**HYDROLOGY STUDY
ADDENDUM #2**

Rainbow Car Wash

Drainage Study Comment Letter

RE: Technical Drainage Study for Rainbow Carwash
PW22-10974
Addendum #2

REVISED FIGURE 9
EXISTING CONDITION
DRAINAGE BASIN MAP

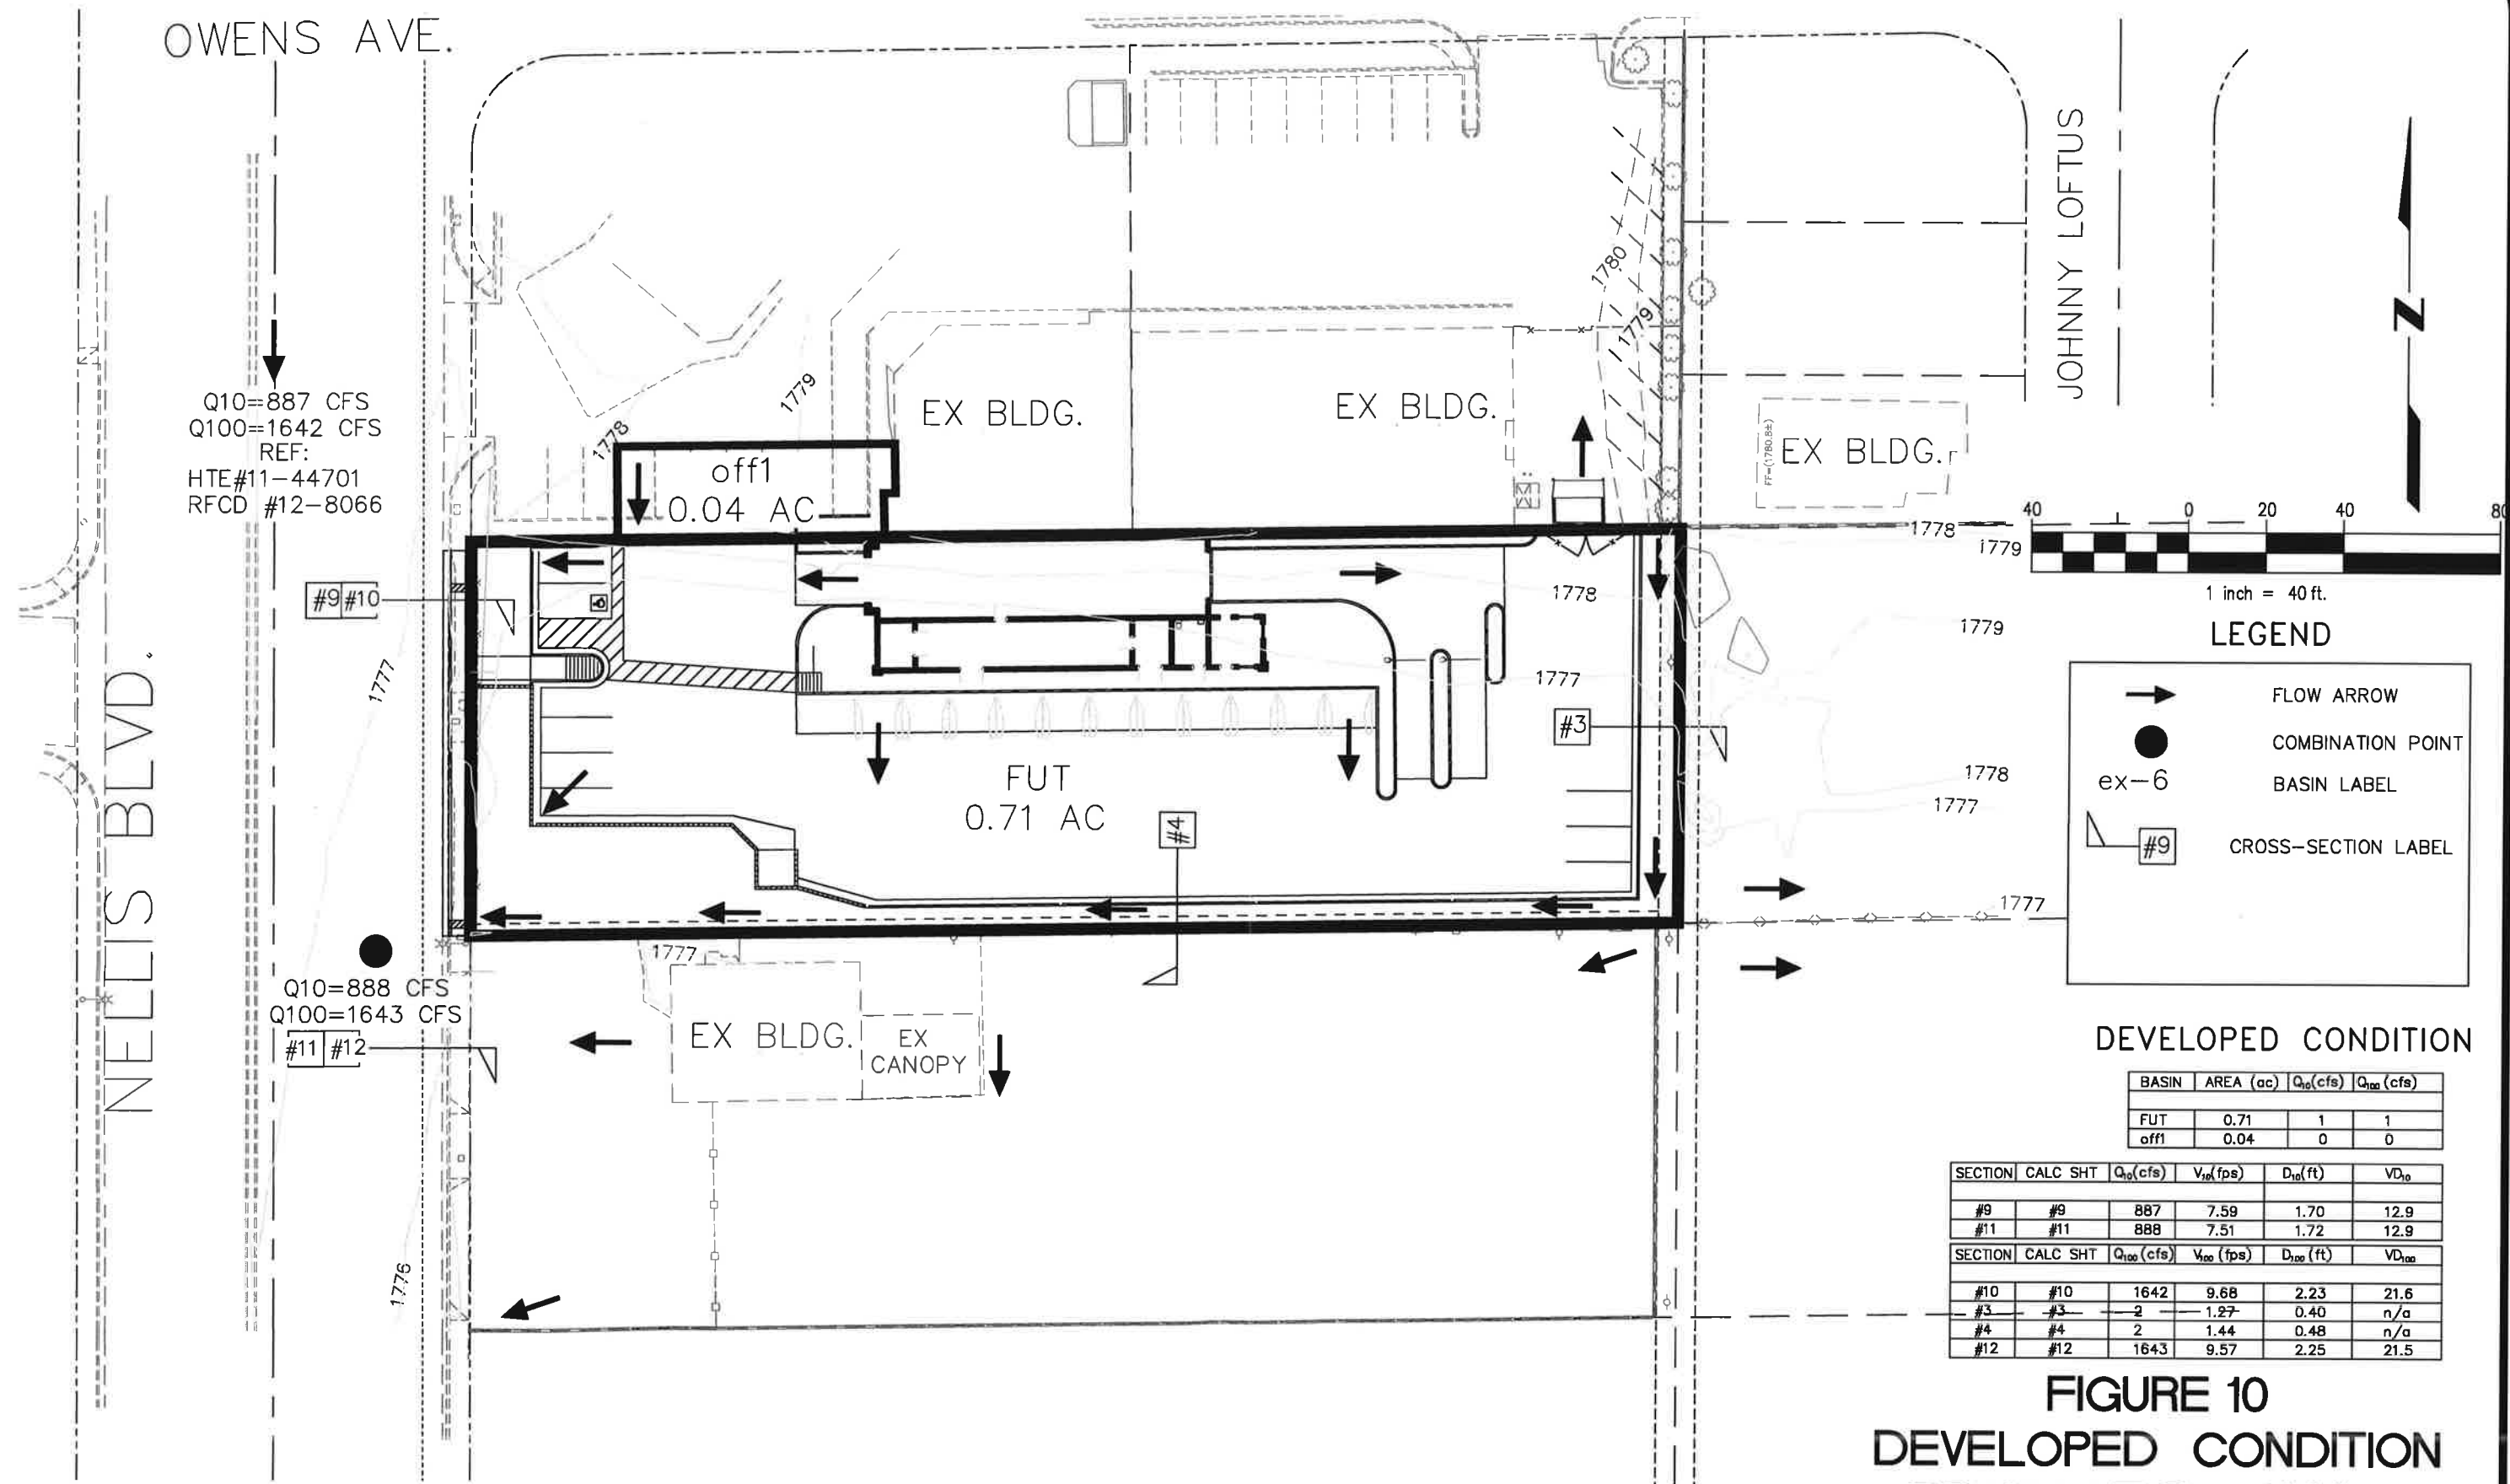
6. The slope in Nellis appears to be 0.41%. Calculations for cross-sections 7 and 8 use 0.73%. Revise Cross-sections 7 and 8 accordingly.
7. Coordinate the onsite detention basin with NDOT. The existing condition shows 1 cfs for onsite Basin EX discharging onto Nellis. The developed condition shows 2 cfs for onsite Basin FUT discharging onto Nellis. It does not appear the additional 1 cfs will be detained onsite. As the current detention calculations stand, it appears the 1 cfs will discharge directly onto Nellis thru a proposed sidewalk underdrain. This is NDOT's issue as flow typically cannot increase onto an NDOT ROW. Provide documentation they approve of the current detention basin calculations or revise design in the next submittal.

7. Coordinate the onsite detention basin with NDOT. The existing condition shows 1 cfs for onsite Basin EX discharging into Nellis. The developed condition shows 2 cfs for onsite Basin FUT discharging into Nellis. It does not appear the additional 1 cfs will be detained onsite. As current detention calculations stand, it appears the 1 cfs will discharge directly onto Nellis thru a proposed sidewalk drain. This is NDOTs issue as flow typically cannot increase onto NDOT ROW. Provide documentation they approve of the current detention basin calculations or revise design on the next submittal.

The developed condition shows 1 cfs discharging into Nellis, not 2 cfs as you have stated.

REVISED Storm Flow Quantities – Existing Condition

Basin	Area	10-Yr	100-Yr
ex	0.71 AC	1 cfs	1 cfs
